# ANADROMOUS WATERS CATALOG/ATLAS CORRECTION FORM

MAP: Ketchikan B-5

WATERWAY NUMBER: 101-47-10250-2007

DESCRIBE CHANGE(S): Stream extension & addition of CTR  
in error change hydrography to <sup>match</sup> 1998 map

Topping of 5/9/01  
= addition to catalog; coho rearing

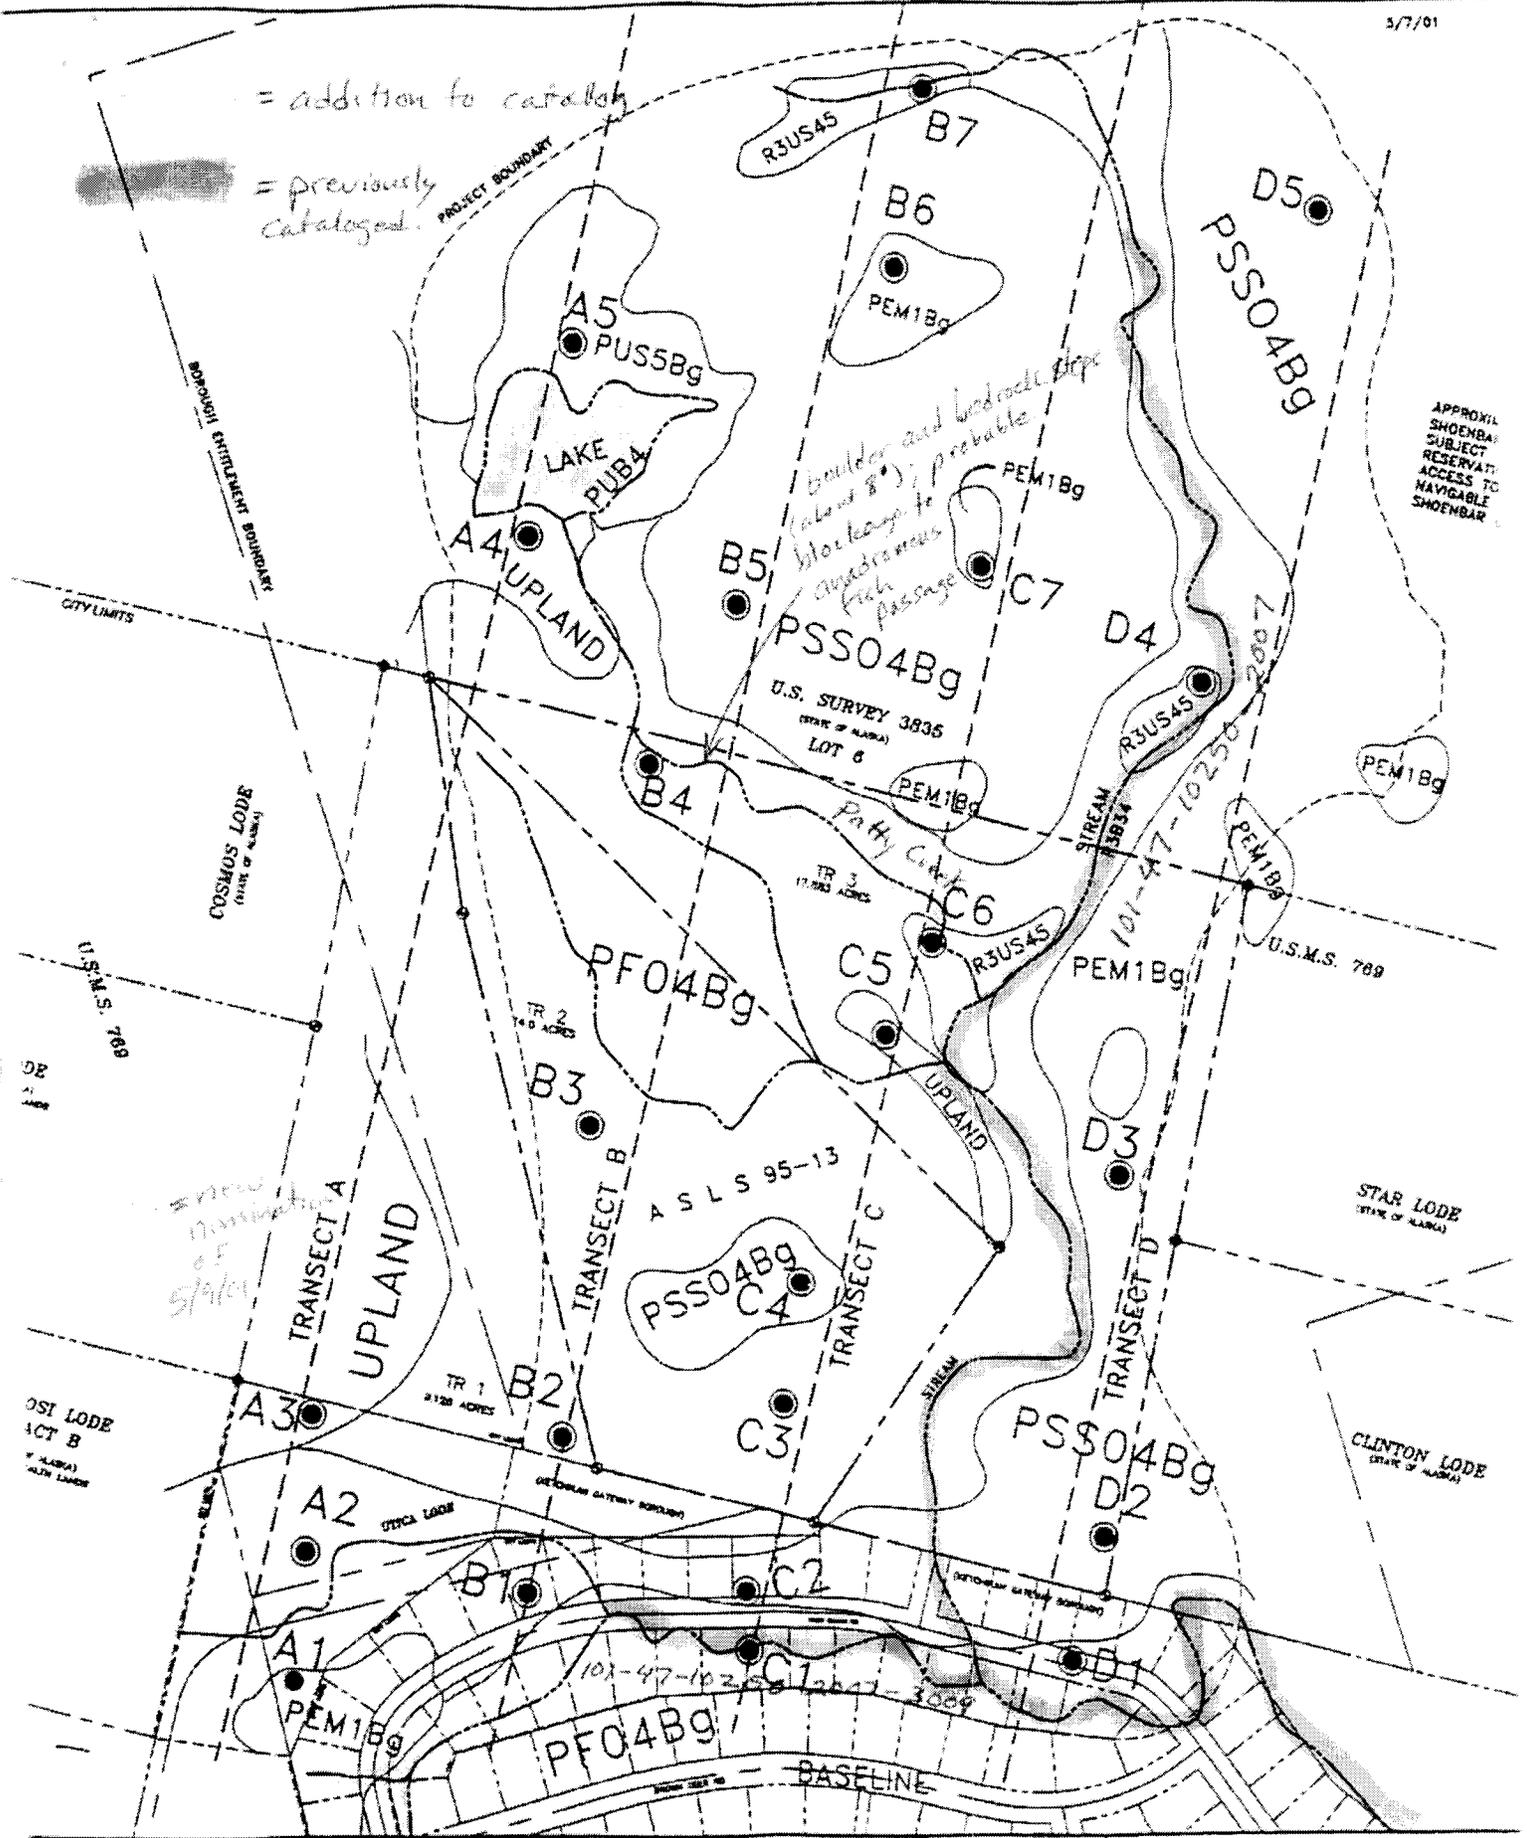
= addition to catalog  
= previously cataloged.

Trapping on 7/12/01  
= addition to catalog; color rearing

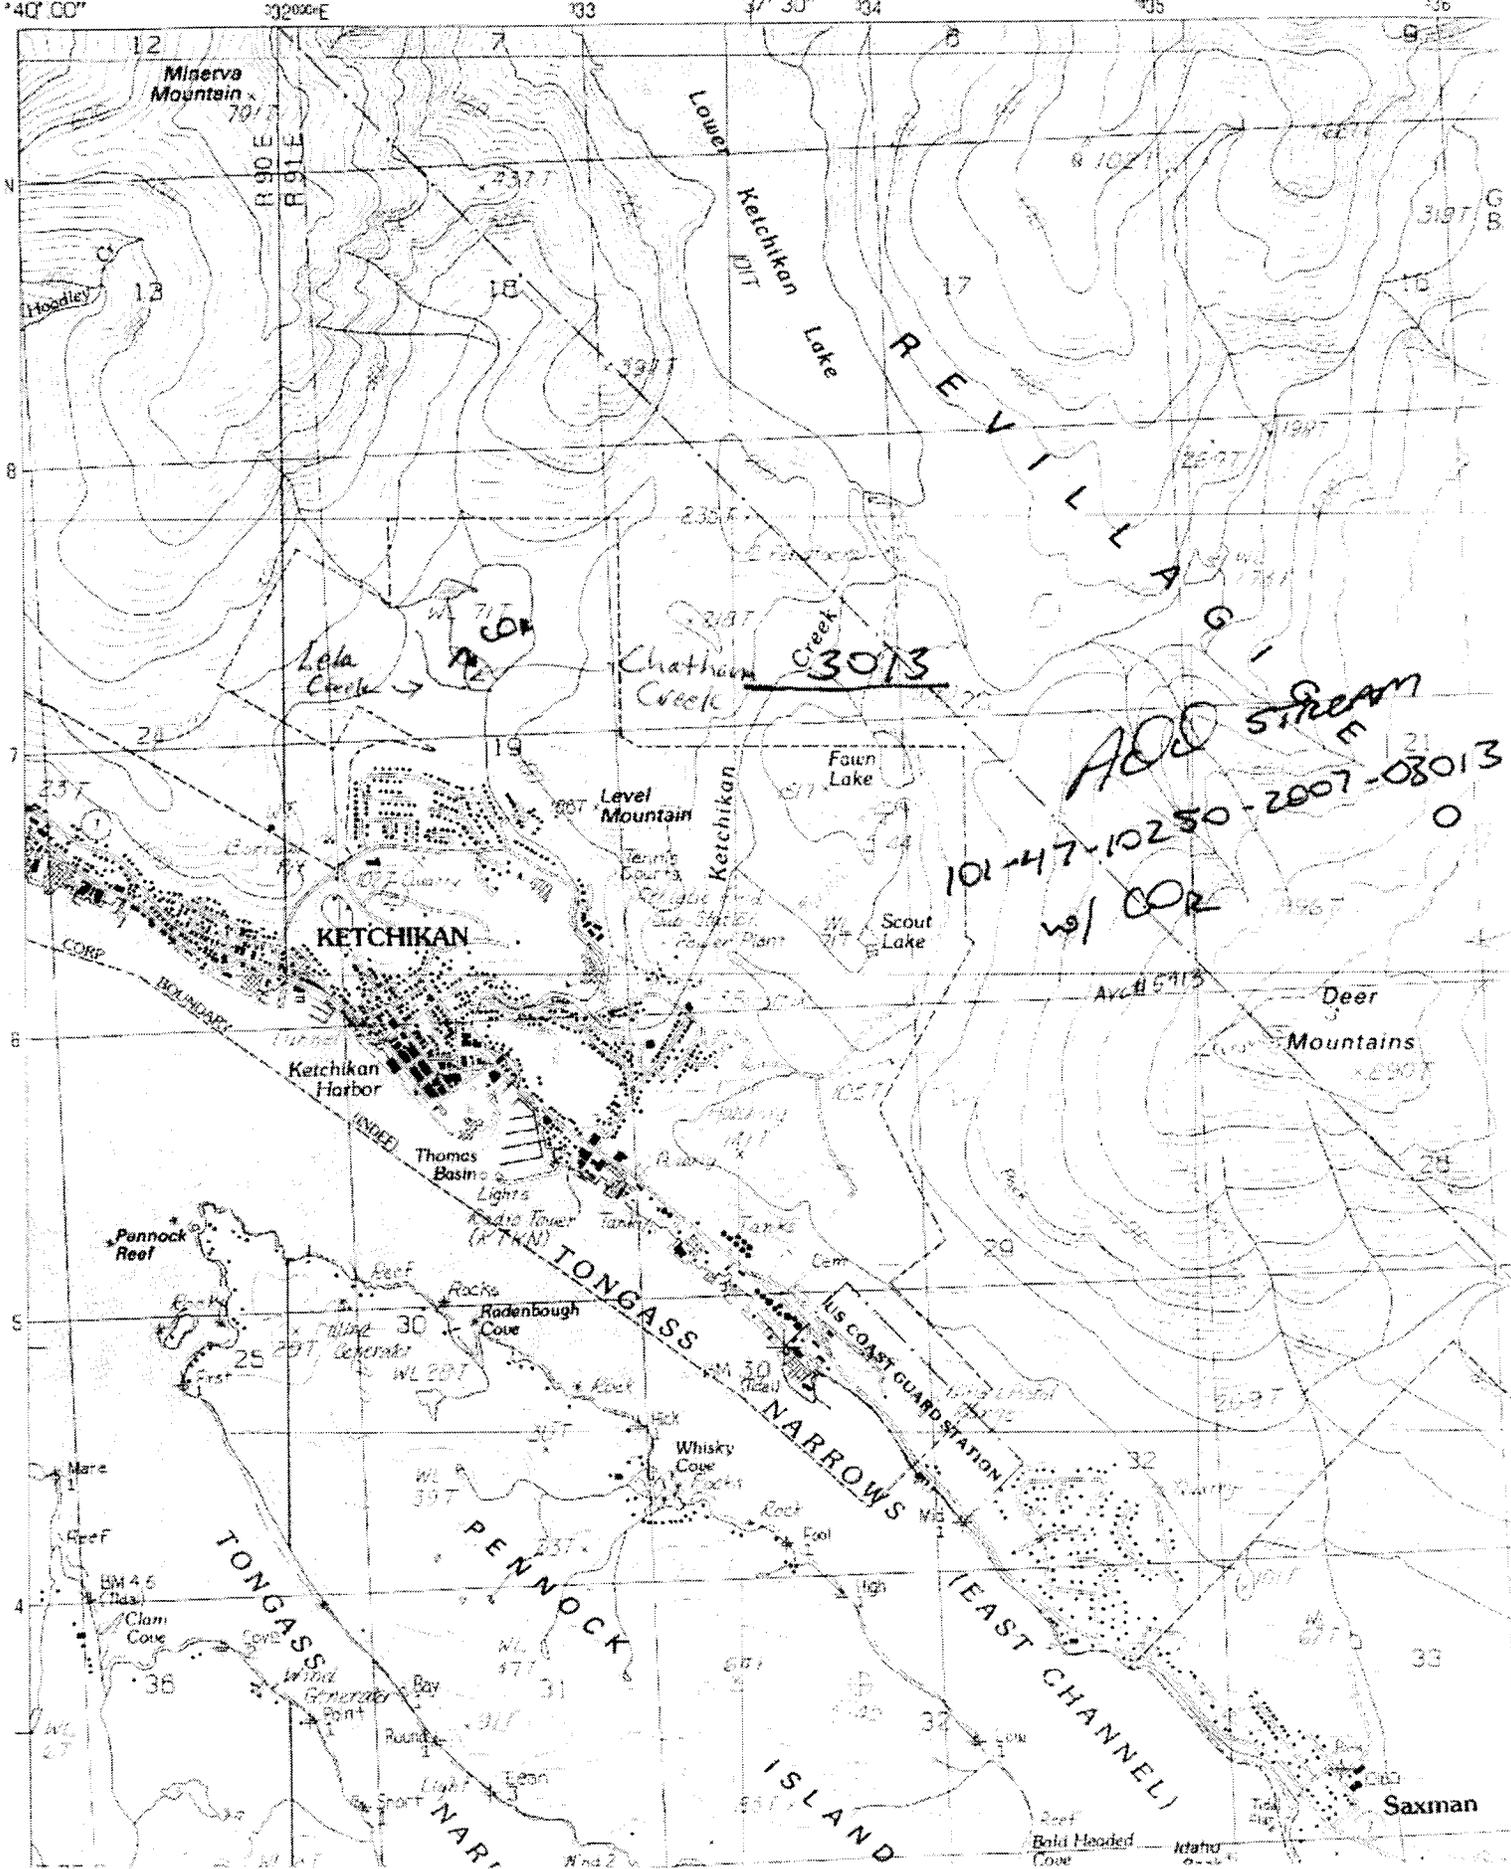
*Clayton  
Location  
of this  
stream*

*Tributary to Schenker Creek 14-47-1024.6-2007*
